ADDENDUM TECHNICAL NOTE RELATING TO DRAINAGE STRATEGY

ROYSTON ROAD (SITE 13) BALDOCK BA4, HERTFORDSHIRE

CHALKDENE DEVELOPMENTS

RR-ISS-XX-XX-TN-C-3000

CLIENT:		CHALKDENE DEVELOPMENTS LTD	
PROJECT:			
ROYSTON ROAD (SITE 13)			
BALDOCK			
SG7 6TD			
DRAWING TITLE:			
PROPOSED DRAINAGE LAYOUT			
(SHEET 3 OF 3)			
JOB NUMBER:		SCALE AT A1:	REV. STATUS:
SE1877		1:200	A
DRAWING NUMBER:		REVISION:	
RR-ISS-XX-XX-DR-C-3012		C04

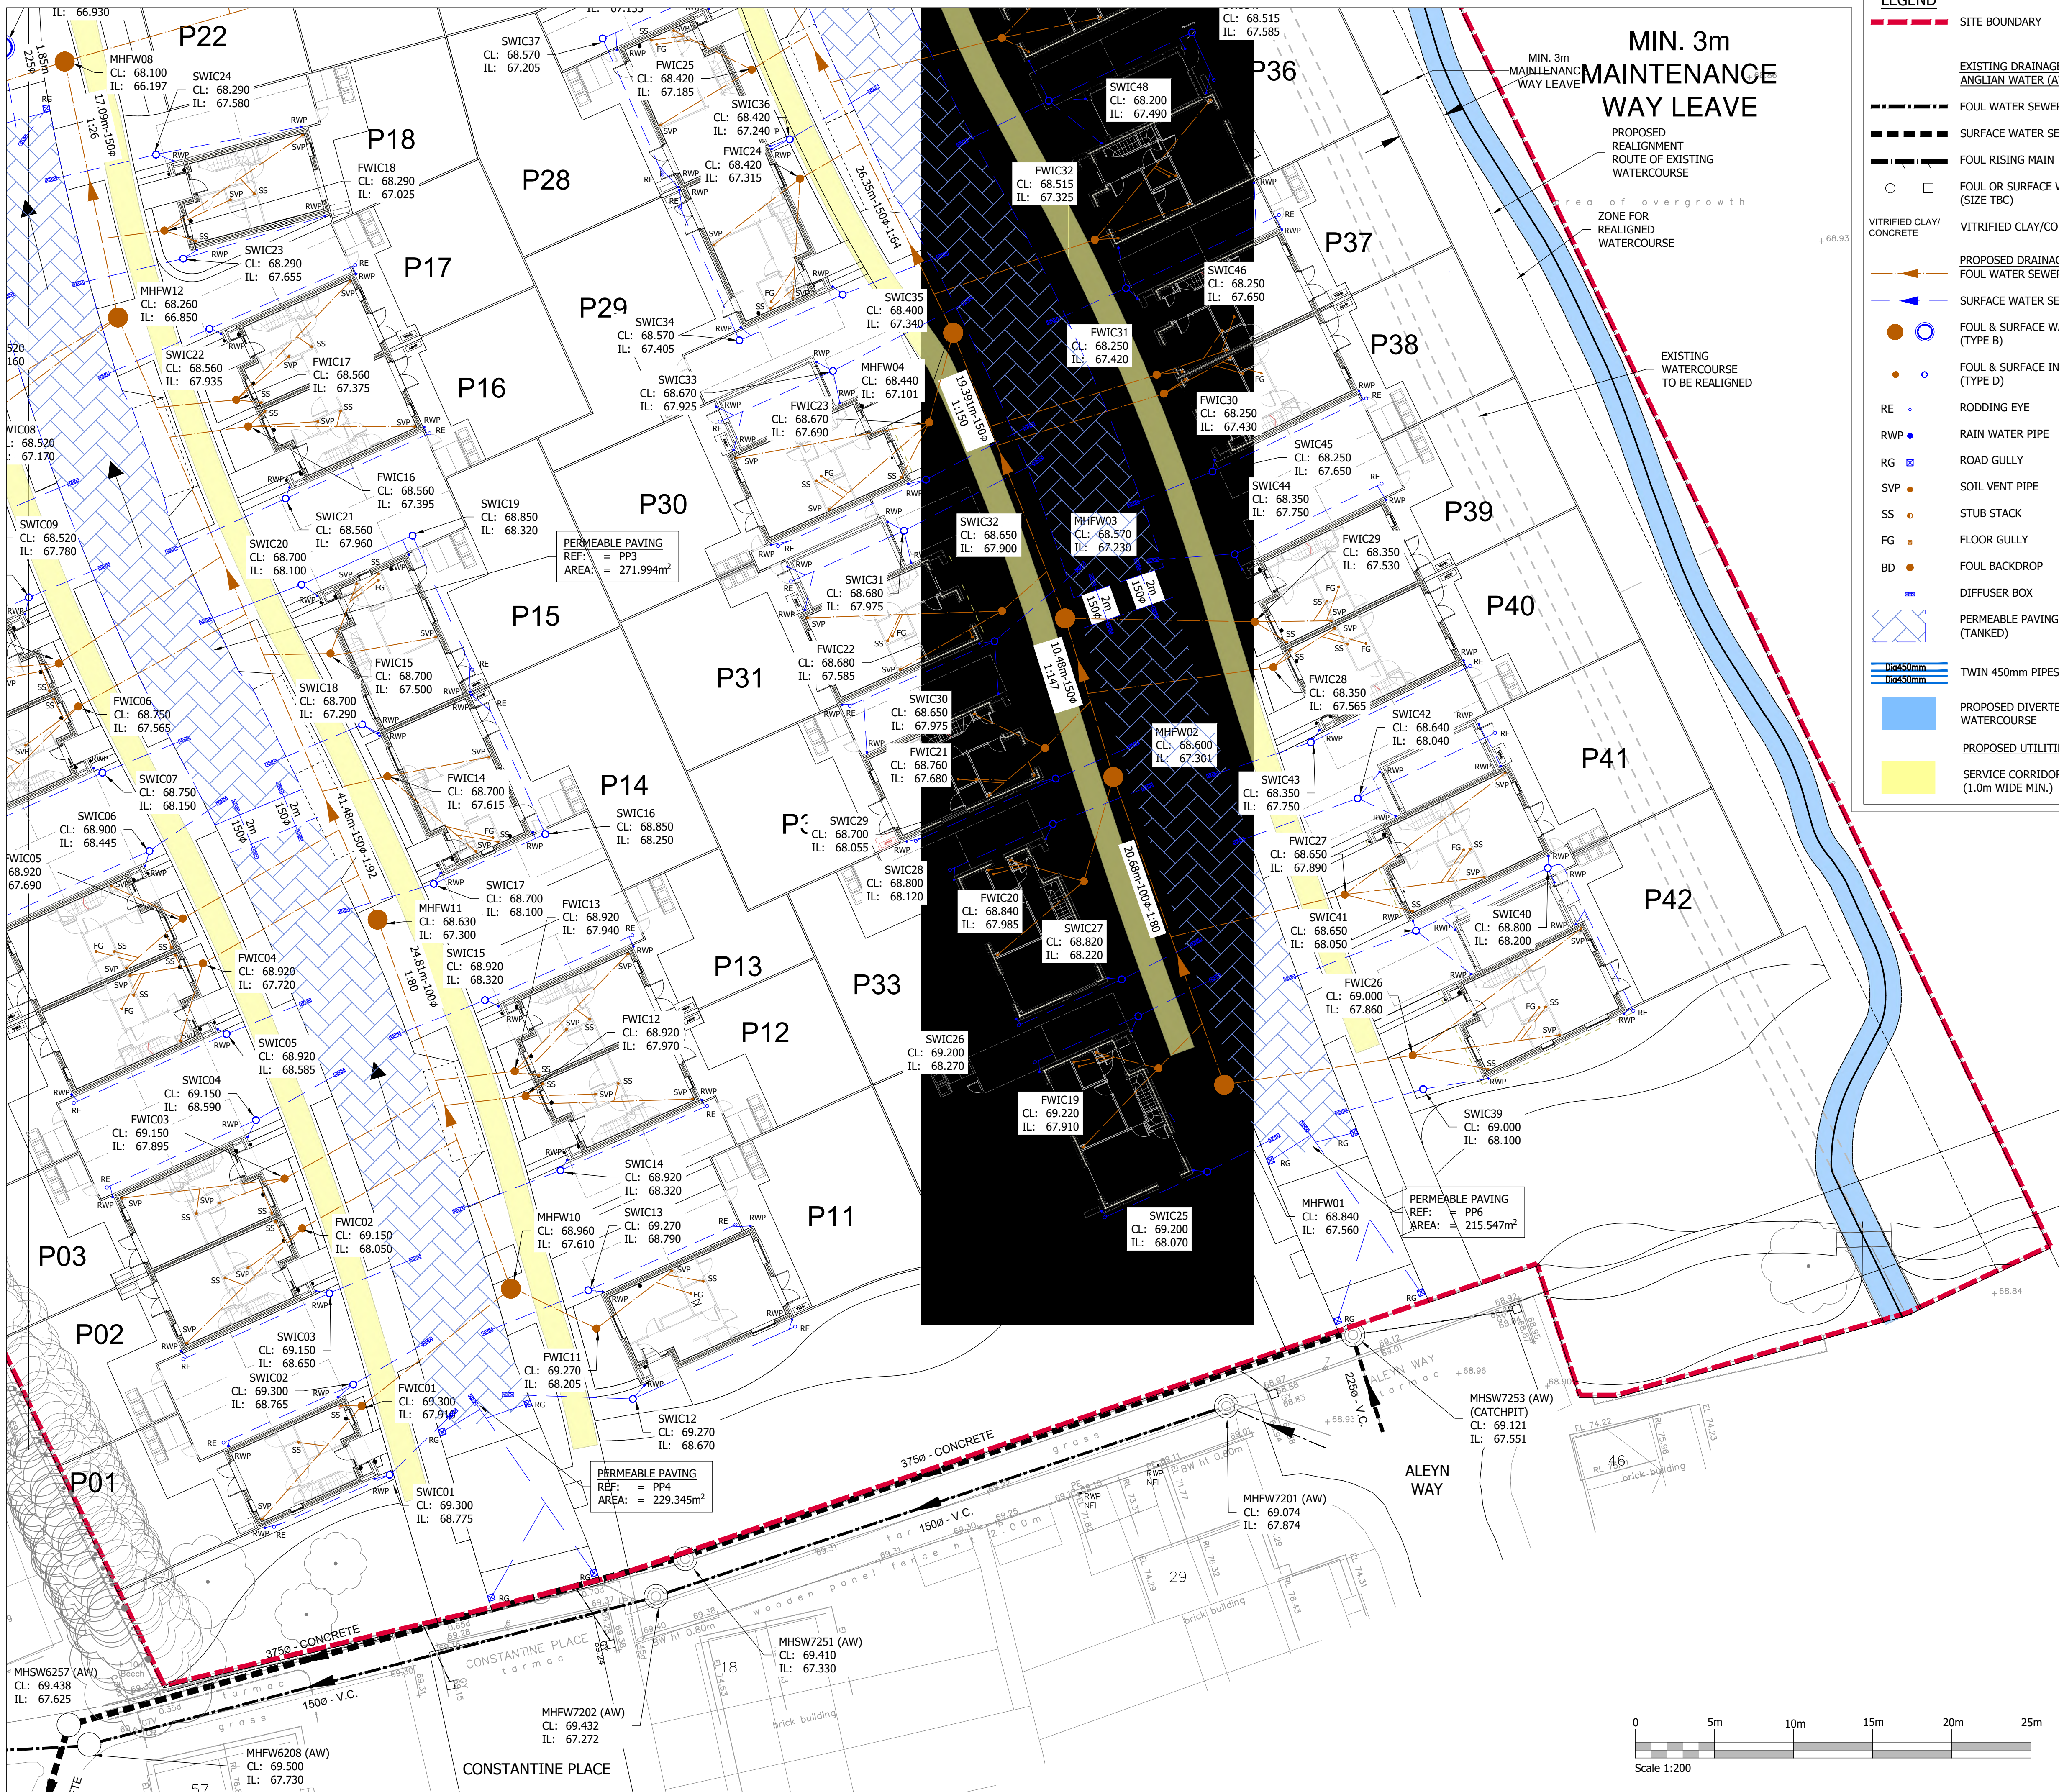
Thank you for these plans. It seems that the new watercourse is going to be generally deeper and steeper than the existing watercourse. Please could proposed side slopes be confirmed? Would it be possible to retain a generally shallower design? This may improve accessibility and avoid any health and safety implications of steeper banks. While the land drainage consent is technically separate from Condition 7, the condition does state that the watercourse should be naturalised and enhanced. The introduction of gentle meandering is welcomed but would be good if depth and slopes could be looked at.

I also note that in some places there is not much room between the proposed top of bank and the fence of the adjoining new dwelling (section D-D shows 2.33m). This may be too small to allow sufficient room to undertake maintenance – we advise a minimum 3m buffer between the top of bank and neighbouring structures to allow sufficient room for access. I note the application form references "Dedicate a minimum 5-10m riparian buffer zone on both sides of the relocated channel, planted with native species. This filters surface runoff before it enters the watercourse"

The watercourse will be 2.0m wide and 0.3m deep to match the existing. This shallow design will avoid any health and safety implications of steeper banks.

C04	12/03/26	GK/RJ	ARCHITECTS HARD LANDSCAPING PLAN UPDATED TO SHOW CORRECT REAR PATIO AREAS AND UPDATED WATERCOURSE LOCATION. NOTES AMENDED TO SUIT
C03	20/02/26	GK/RJ	DRAINAGE AND WATERCOURSE UPDATED AFTER REVIEWING COMMENTS RECEIVED
C02	18/02/26	GK/RJ	PERMEABLE PAVING UNDER RAMPS OMITTED AND GULLIES ADDED AT SITE ACCESSSES. SERVICE CORRIDOR HAS BEEN UPDATED TO SUIT LATEST M&E LAYOUT. TABLETOPS AT SOUTH OF SITE HAVE BEEN AMENDED TO SUIT GULLY POSITIONS. MANHOLE COVER LEVELS HAVE BEEN AMENDED TO SUIT REVISED LEVELS
C01	30/01/26	GK/RJ	ISSUED FOR CONSTRUCTION
P14	05/12/25	GK/RJ	SITE PLAN UPDATED AND DRAINAGE AMENDED TO SUIT
P01	07/05/21	AS/RJ	ISSUED FOR INFORMATION
REV	DATE	DRAWN/CHK	REVISION INFO
STATUS:
